Ref: 300300107

**NSW Department of Planning and Environment  
New Primary School at Warnervale – Traffic Engineering Statement**

Stantec has reviewed the comments register dated 28 November 2019 (*CPS comments – 191128 – Response to Submission Tracker – Warnervale*) and has provided responses in the following response table:

75 Warervale Road, Warnervale  
Swept Path Assessment  
12.5m Long School Bus Entry / Exit

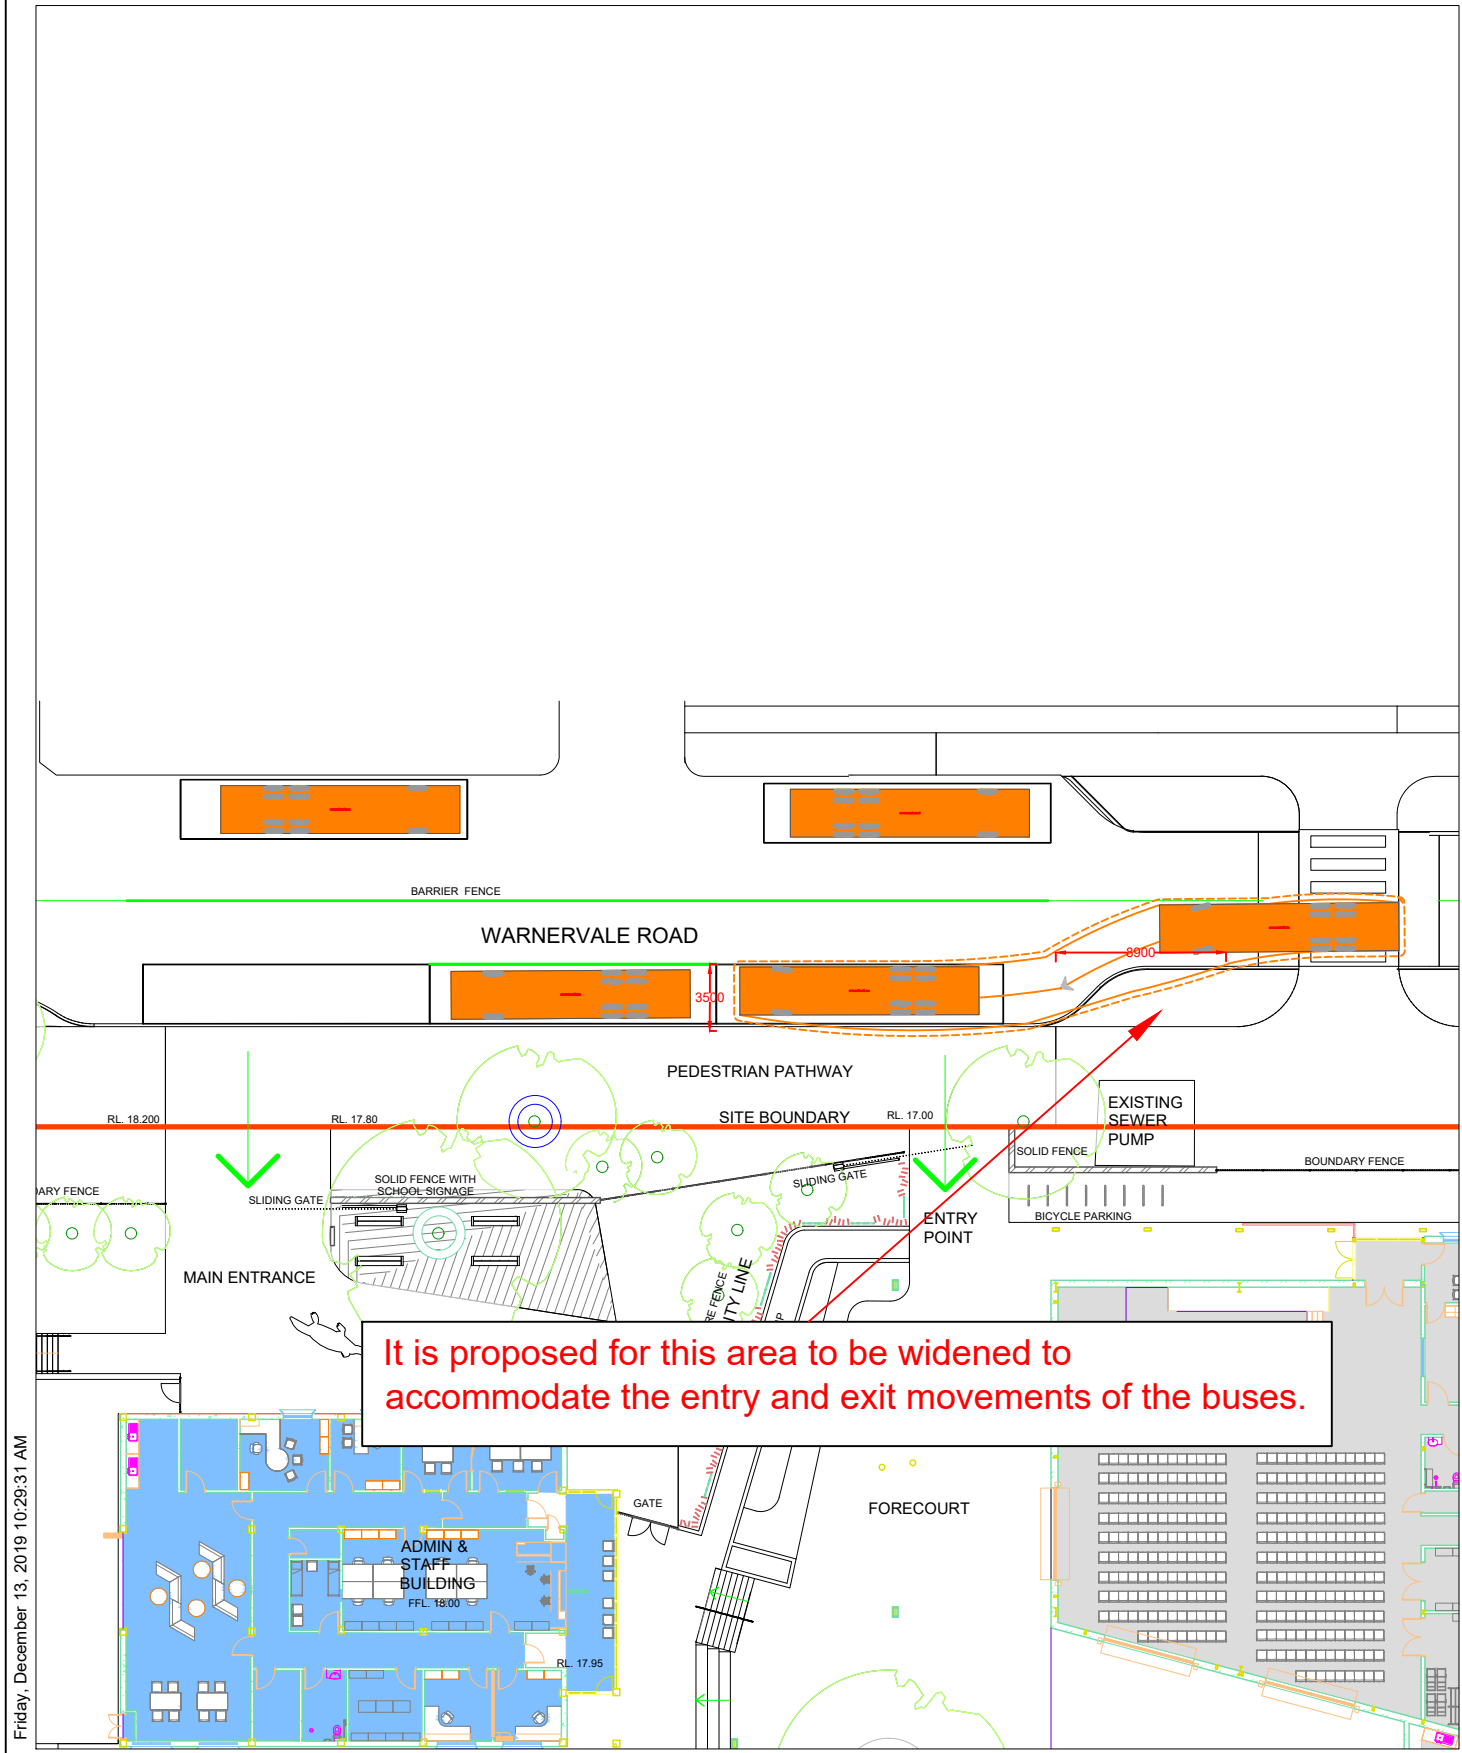
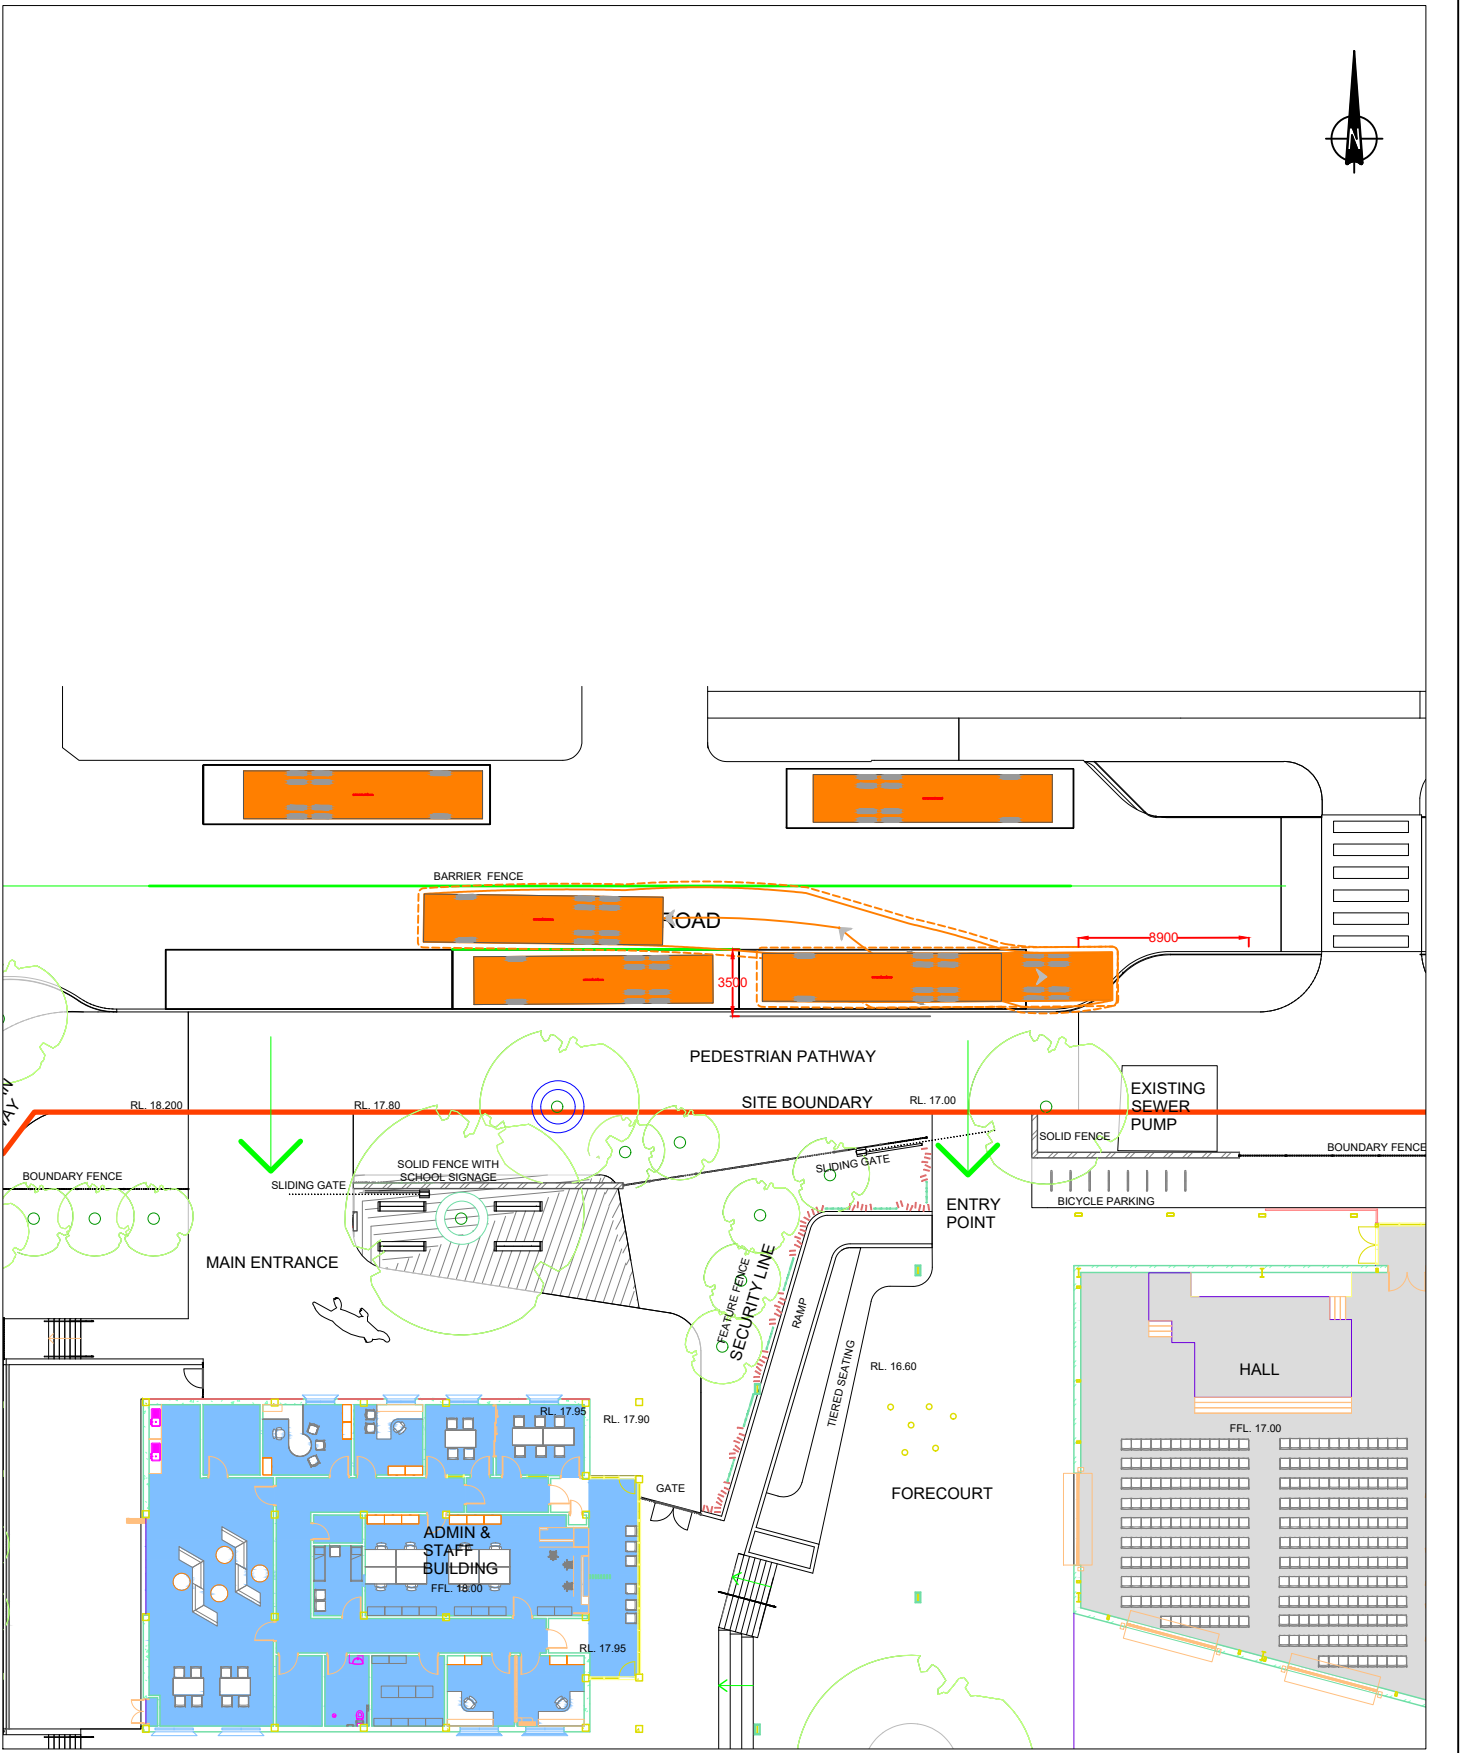
| 3 | The bus bay on the southern side of Warnervale Road must be long enough to accommodate 3 buses with appropriate entry and exit tapers.  | <p>A swept path assessment has been undertaken.</p> <p>Adjustments have to be made to the footpaths to accommodate entry and exit movements for the buses. See swept paths attached in Appendix A.</p> <p>This will be undertaken at the detailed design stage.</p>   |

It is proposed for this area to be widened to accommodate the entry and exit movements of the buses.

75 Warnervale Road, Warnervale  
Sight Distance Assessment

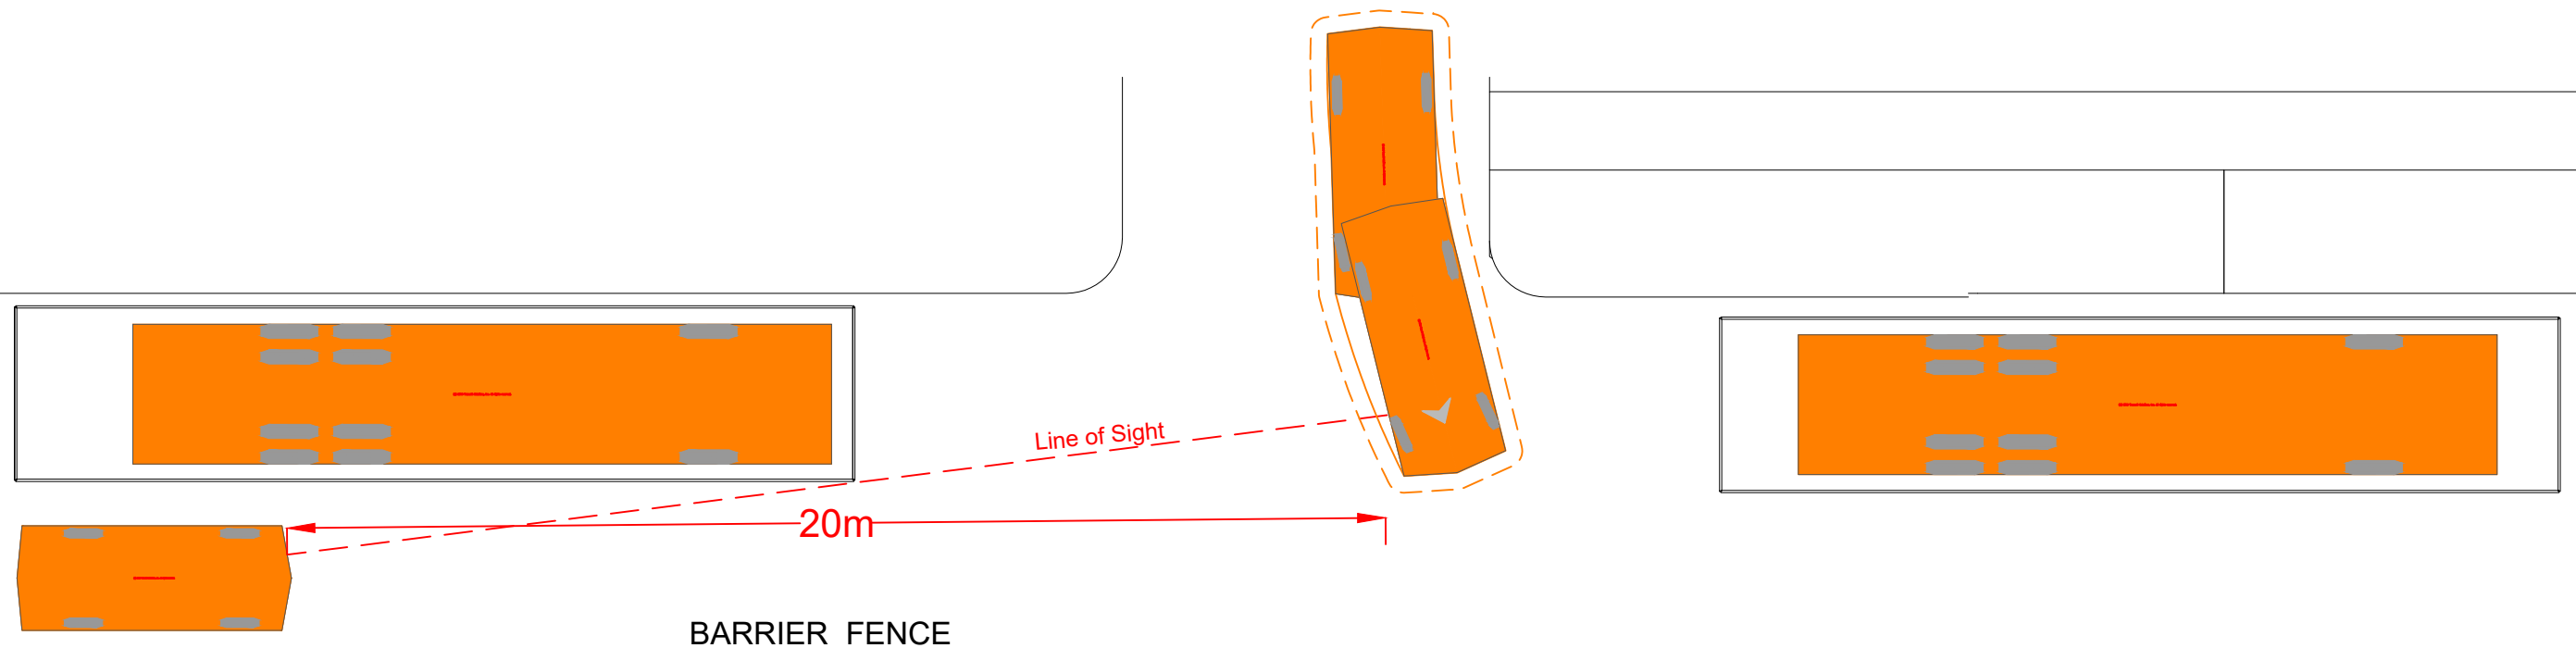
| 4 | Buses parked on the northern side of Warnervale Road will obstruct sight lines from the driveways in the PM period.   | <p>As shown in Figure 3 of Appendix A, vehicles will be able exit the driveways on the north side of Warnervale Road, with no obstructions to the sight lines.</p> <p>It is expected that approaching vehicles from Warnervale Road will slowdown in a school zone environment.</p>   |
